HISTORIC LANDMARK COMMISSION STAFF REPORT

**Ownbey Residence
New Construction
PLNHLC2013-00933
and PLNHLC2013-00934
88 N. 'T' Street
January 16, 2014**

Planning Division
Department of Community and
Economic Development

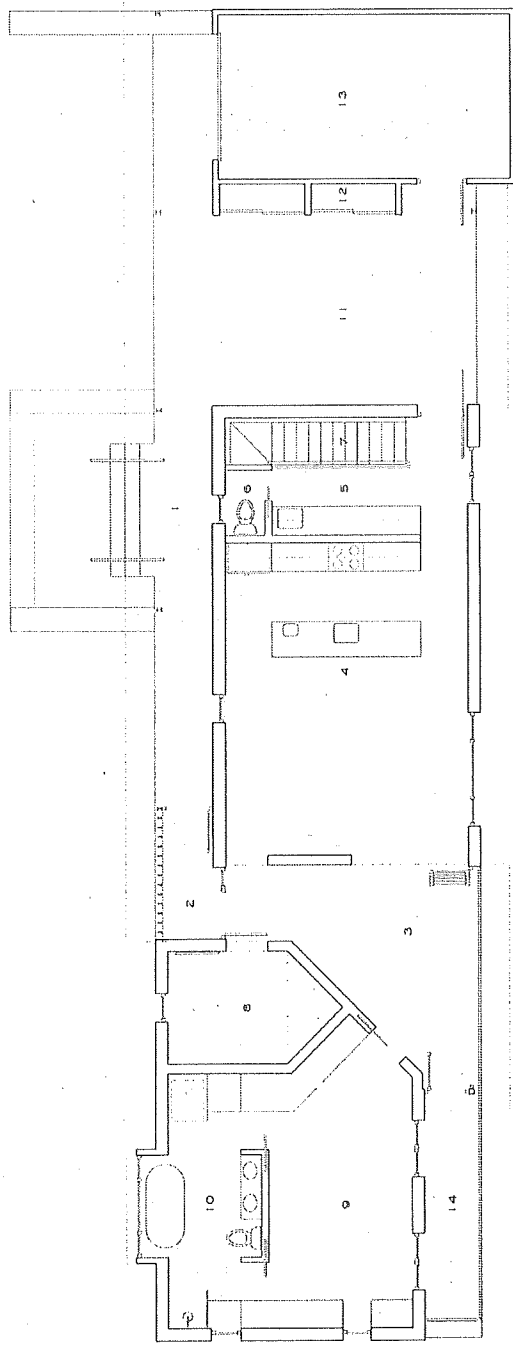
- **Interior side yard setback:** 4 feet. The site plan indicates that at 1 foot the proposed attached garage module fails to meet this standard. *The applicant seeks a special exception to modify this requirement, but due to an oversight in noticing this request will be reviewed administratively.*

- **Building coverage:** Forty percent 40% of the lot area. The main portion of the building has a footprint of 1,426 square feet and together with the parking accommodations the lot coverage is 49%. *The applicant seeks a special exception to modify this requirement.* A discussion of this request appears on page 12 of this staff report.

- 3) No setback data has been provided to verify that 19.5 feet front yard setback measurements where calculated in compliance with 21A.24.080.E.1.b.
- 4) The garage and structural roof supports to not comply with the interior side yard and rear yard setback requirements. The garage is considered attached as per 21A.62:
GARAGE, ATTACHED: "Attached garage" means an accessory building which has a roof or wall of which fifty percent (50%) or more is attached and in common with a dwelling. Where the accessory building is attached to a dwelling in this manner, it shall be considered part of the dwelling and shall be subject to all yard requirements of the main building.
To be considered detached, the garage should be located at least four feet behind the dwelling (measured nearest point to nearest point). An open fire rated breezeway meeting building code requirements may be constructed to connect the garage to the dwelling provided that the connection is less than 50% of common garage wall or roof.

- 5) If considered as a detached garage, the proposed detached garage shows a 16 feet setback from the sidewalk and a 20 feet setback from the sidewalk is required by section 21A.40.050.A.2. The site plan also shows a 22 feet deep garage, however a 20 feet deep garage will meet the minimum 17.5 feet required for a parking stall. The plans also show the garage is setback only 10.44 inches from the south property line when 12 inches is the minimum requirement. A dimension is needed to document distance from neighbor's house.

The proposed detached garage shows a 16 foot setback from the sidewalk and a 20 foot setback from the sidewalk is required by section 21A.40.050.A.2. The site plan also shows a 22 foot deep garage, however a 20 foot deep garage will easily meet the minimum 17.5 feet required for a parking stall. The plans also show the garage is setback only 10.44 inches from the south property line when 12 inches is the minimum requirement.

The applicant will also need to show that no portion of the proposed garage is closer than 10 feet to any portion of the dwelling on the neighboring lot to the east.

The drawings show the required two onsite parking stalls, a single car garage and a single stall carport. The garage set back is only 16.5' and needs signage placed on the garage door "No parking in front of garage door" to regulate vehicle encroachment on public sidewalk. (minimum stall depth is 17.5')

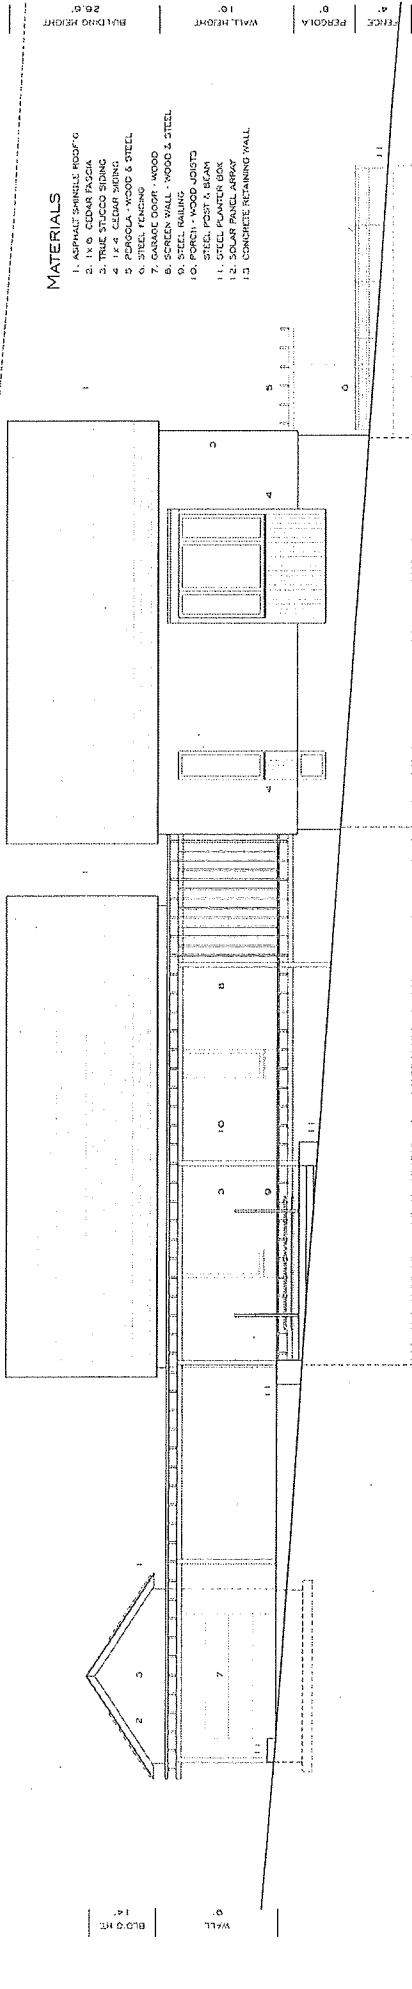
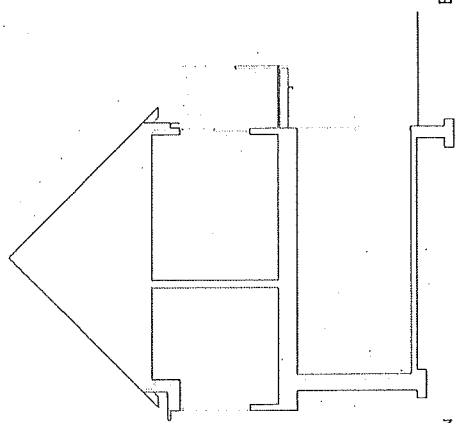
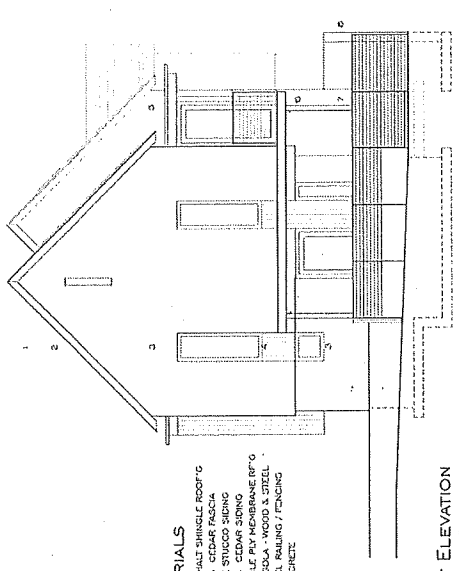
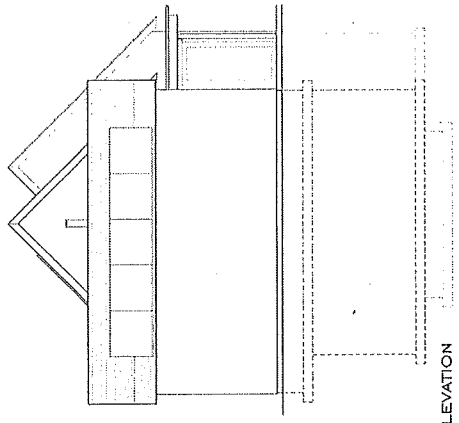
- **Maximum exterior wall height:** Sixteen feet (16') for exterior walls placed at the building setback established by the minimum required yard. The proposed exterior wall heights appear to measure no more than 16 feet and meet this requirement.

Analysis: The gable ends of the proposed building face north and west. Low profile solar collectors will be flush mounted on both slopes of the garage roof and cover the south roof slope of the main portion of the building. The submitted plans show a paneled system with each panel measuring approximately 39”(w) x 65”(h) x 2”(d).
